CERTIFICATE OF APPROPRIATENESS
Minor Works

CERTIFICATE NUMBER: 16-57 **DATE ISSUED:** 8/24/16

NAME OF LANDMARK: **Parks-Cramer Building**

**ATHERTON MILL
LANDLORD IMPROVEMENTS
FLOOR REPLACEMENT AT UNIT 640 AND TEMP. RAMP**
2000 SOUTH BLVD.
CHARLOTTE, NC
DEMOLITION PLAN

1 DEMO PLAN
SCALE: 3/32" = 1'-0"

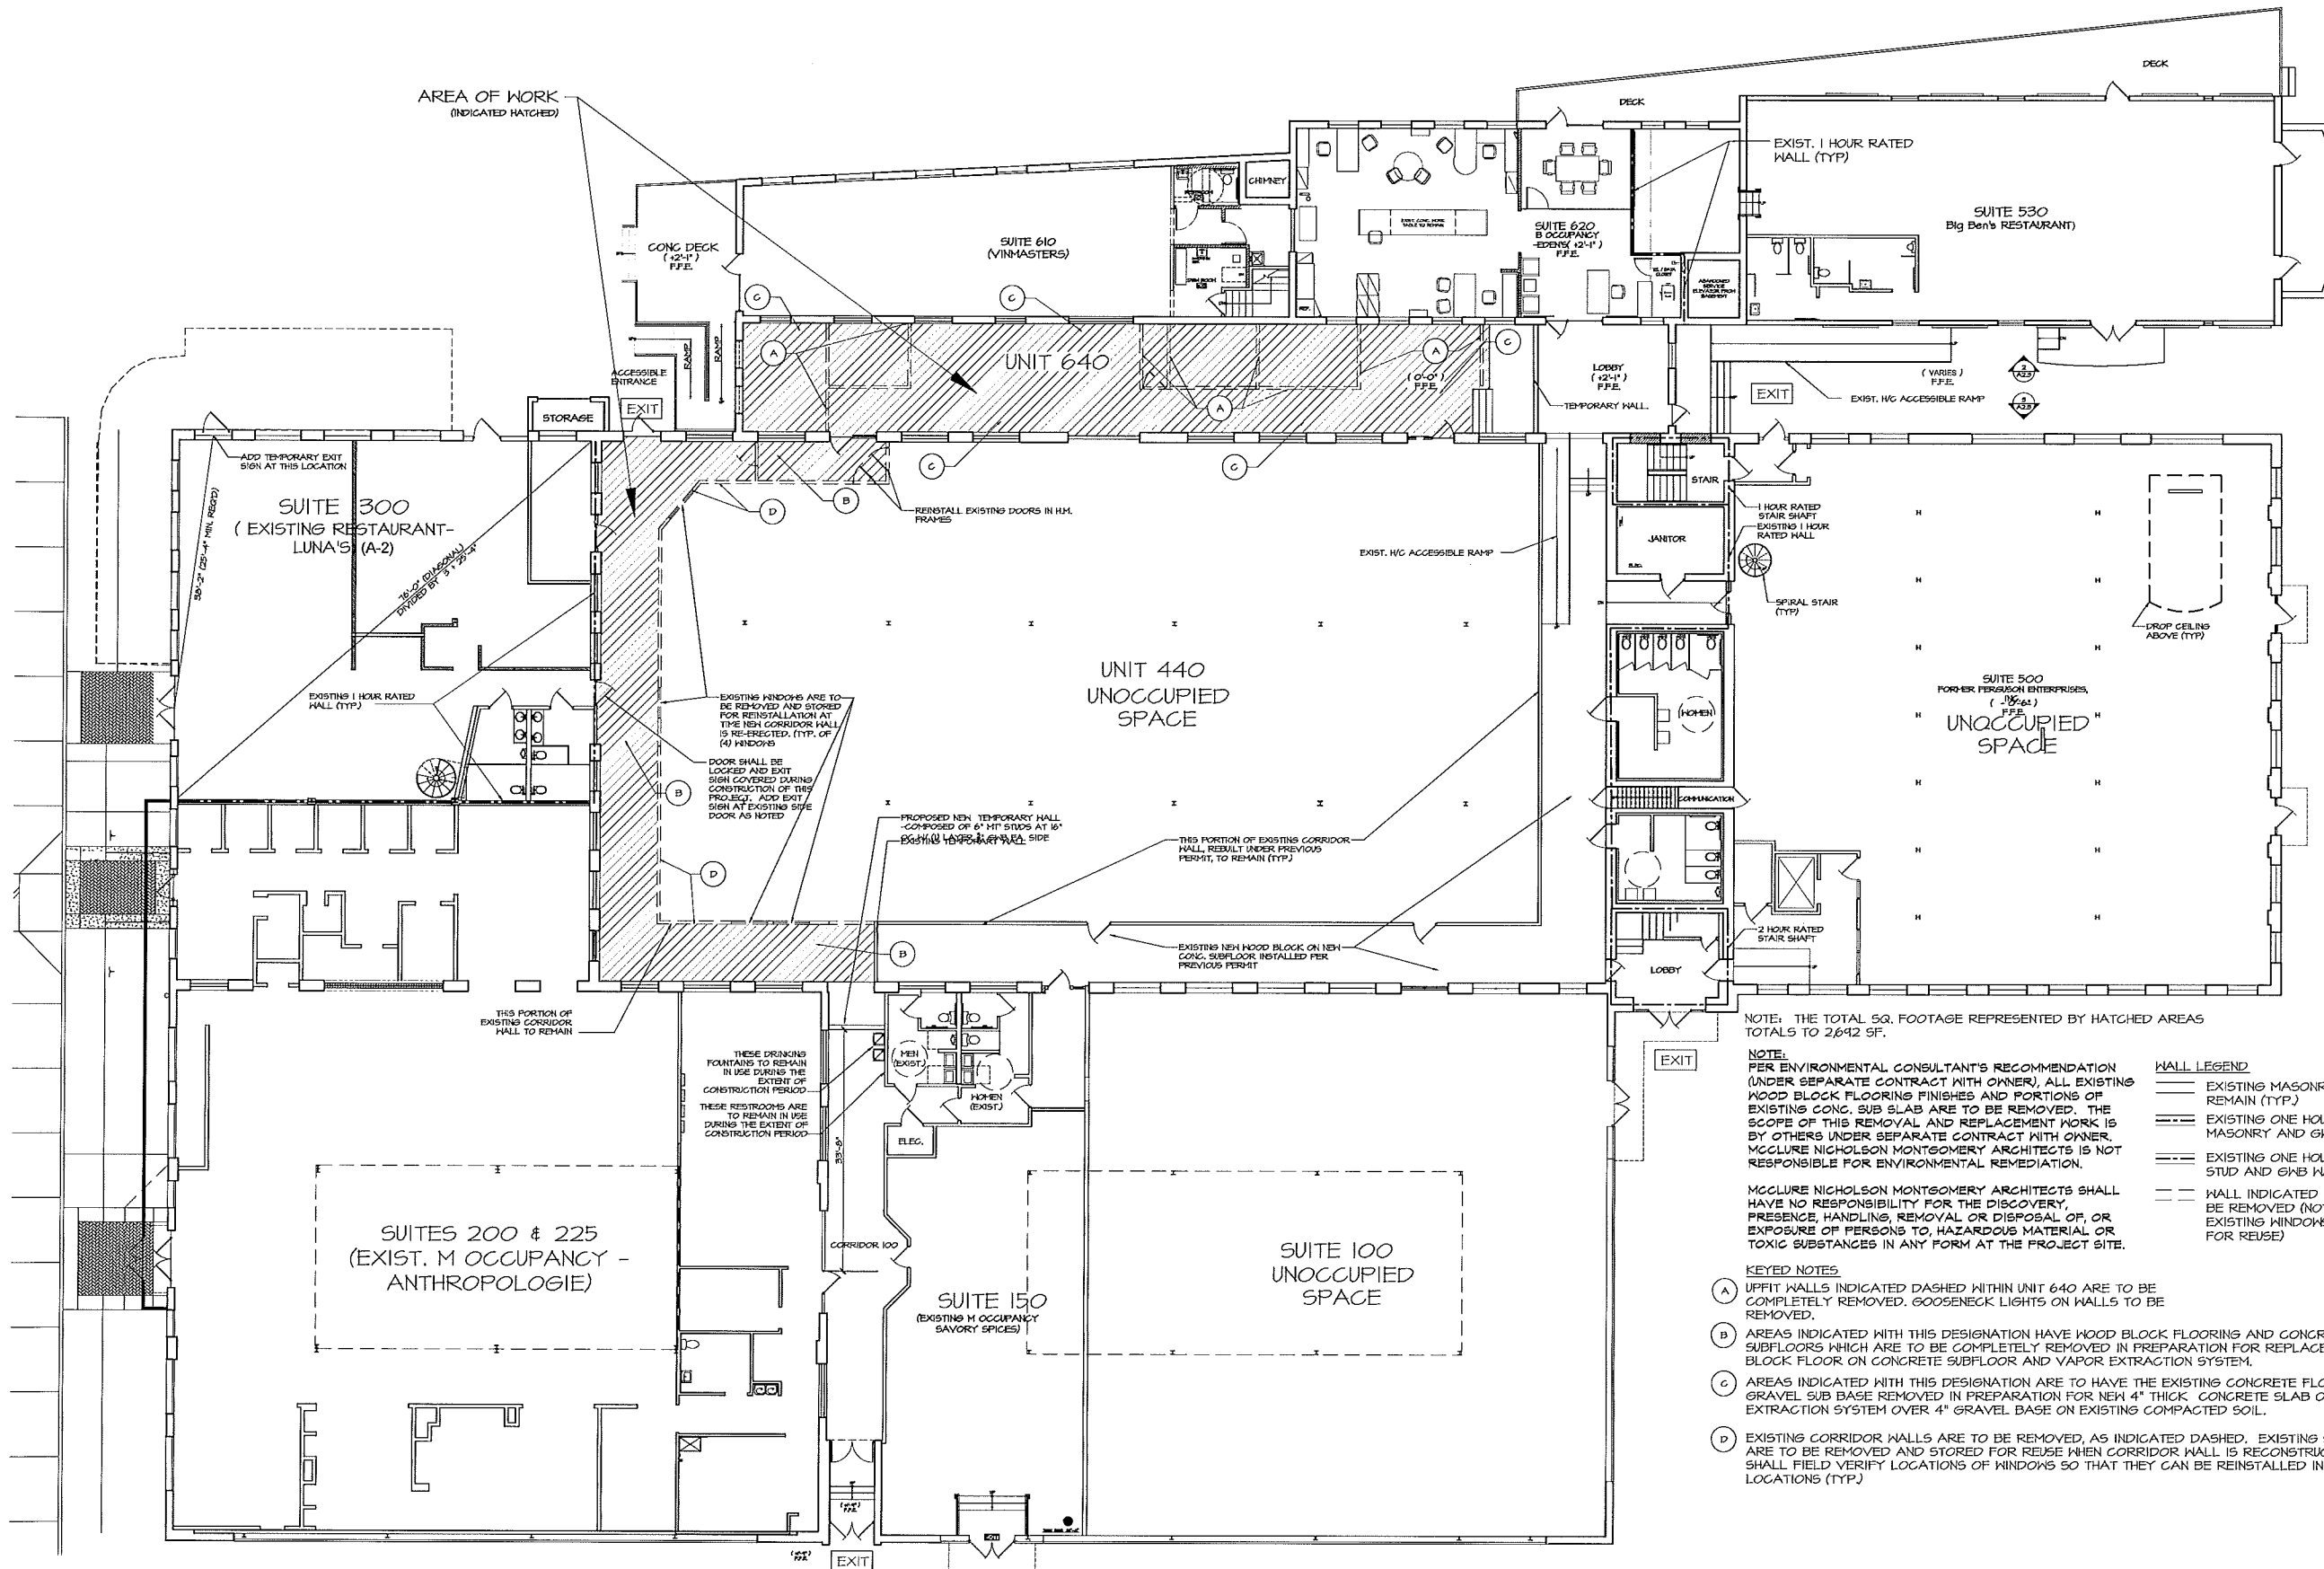
The Historic Landmarks Commission has reviewed the proposed activity and has found the following aspects to be in compliance with the Secretary of the Interior's Standards for Rehabilitation and Guidelines for Rehabilitating Historic Buildings and, therefore, has found them to be appropriate:

Removal of existing flooring and other alterations to the interior of the building as shown on the attached plan.
